No. **96-1**

SUBJECT: 1996 Shop Manual

No. **96-2**
REVISION 1

SUBJECT : Spring Chart

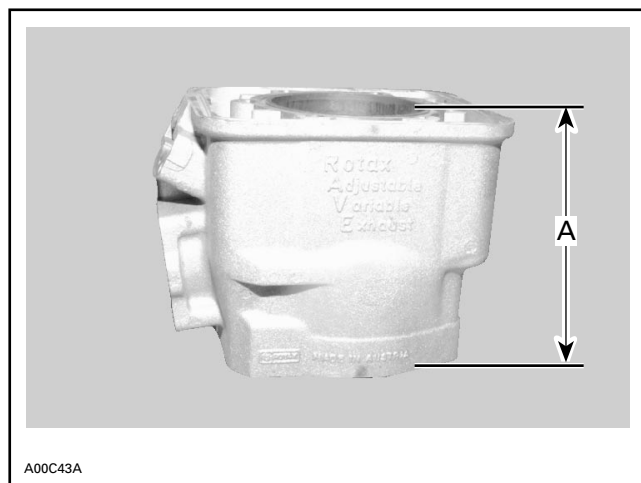
Different cylinder heights exist for the 670 type engines.

Do not use the replacement cylinder P/N 420 9231 95 on the 1st series of the 1995 (1994 1/2) Summit or any 1994 and older 670 type engines, without first checking the cylinder height.

For older 670 type engines the superseded cylinder P/N 420 9291 93 with the correct height is now available.

Cylinder height is determined by measuring from the base gasket surface to the top of the cylinder liner (A) (not the cylinder water jacket casting). Refer to the following illustration.

Specifications	
P / N	Height + 0.1 mm (0.004 in)
420 9135 27 original (old) number 420 9291 93 superseded (new) number	121.5 mm (4.783 in)
420 9231 95 newer cylinder	121.3 mm (4.776 in)

Cylinder P/N 420 9231 95 is the cylinder used on the 2nd series 1995 Summit 670, the 1995 Formula SS and 1995 Grand Touring SE.

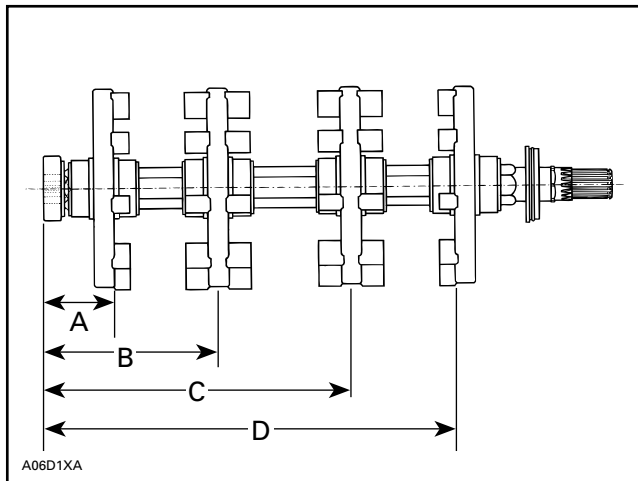
When reinstalling the sprockets on the drive axle on the above mentioned models, note the revised measurements.

Sprockets must be assembled as follows.

- A. 65.8 mm (2-9/16 in)
- B. 159.3 mm (6-1/4 in)
- C. 282.3 mm (11-1/16 in)
- D. 375.8 mm (14-3/4 in)

NOTE : Alignment of center sprockets are measured center to center. Whereas, the outer sprockets are not.

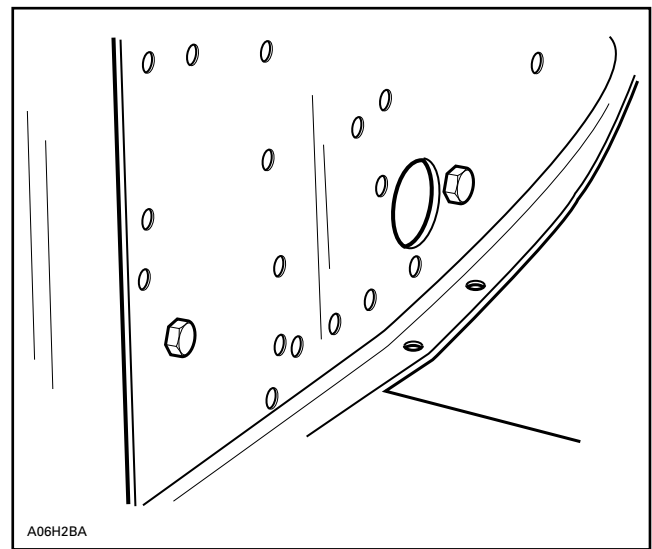
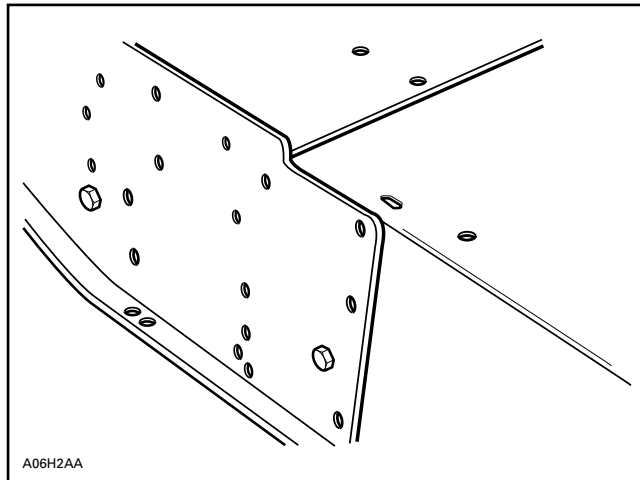
When replacing either a front member or a tunnel (see the attached part number list) be sure to properly align them when reassembling.

Align the tunnel and the front member to each other by pushing them firmly together.

Install three 10 mm bolts and one 8 mm bolt in the following locations.

A 10 mm bolt in both holes for the front arm of the rear suspension.

A 10 mm bolt in the front mounting hole for the chaincase.

An 8 mm bolt in the front drive shaft bearing mounting hole.

1. 3 of the 4 M6 x 25 Allen screw locations

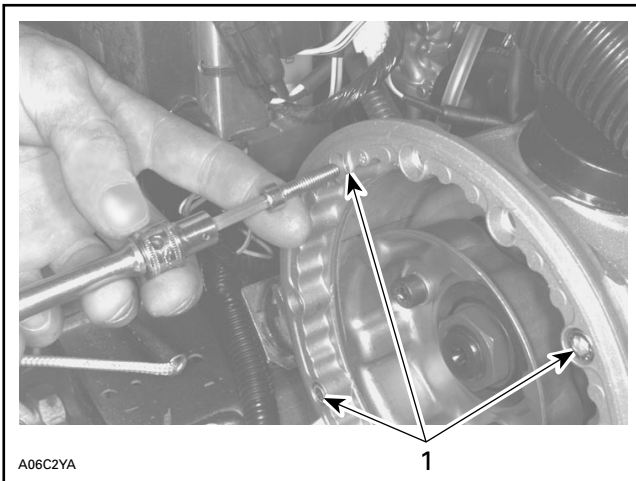
For easier pulling when manually starting a vehicle install the new large diameter rewind starter assembly and related parts.

Install the adapter flange to the crankcase with 4 M6 x 25 Allen screws, torque them to 9 N•m (7 lbf•ft).

1. Notch aligned with the embossment

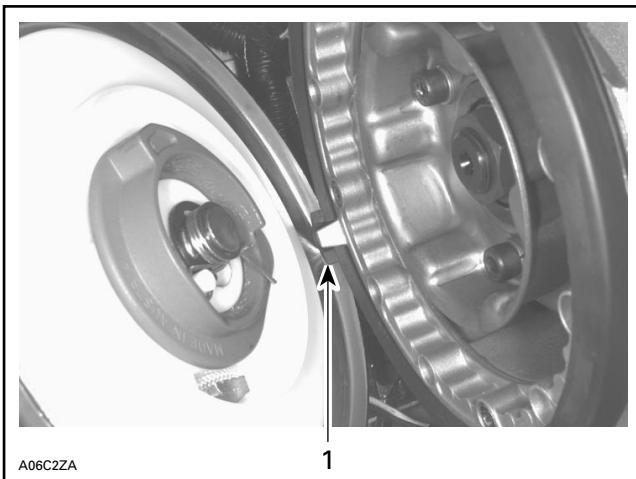
Install the rewind assembly aligning the cut out in the rewind with the notch in the adapter flange.

Install the rewind clamp aligning the notch with the embossment in the adapter flange. Tighten the screw on the rewind clamp to 9 N•m (7 lbf•ft).

1. *Apply anti-seize lubricant on threads*

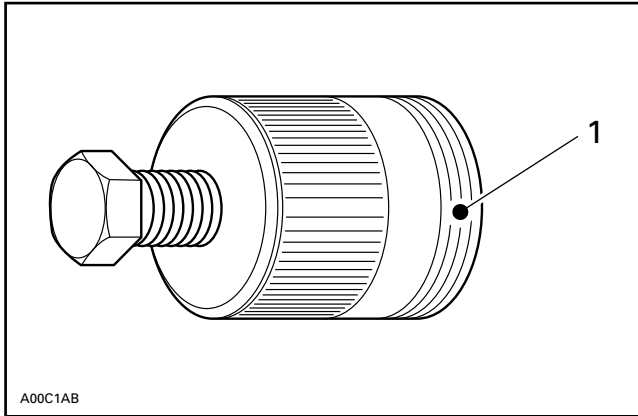
When using the magneto puller in conjunction with the puller ring to remove the magneto fly-wheel from the crankshaft, apply a thin coat of anti-seize lubricant (P / N 413 7010 00) on threads of puller tool.

This will prevent any sticking or damage to tool threads, providing a long life span of both tools.
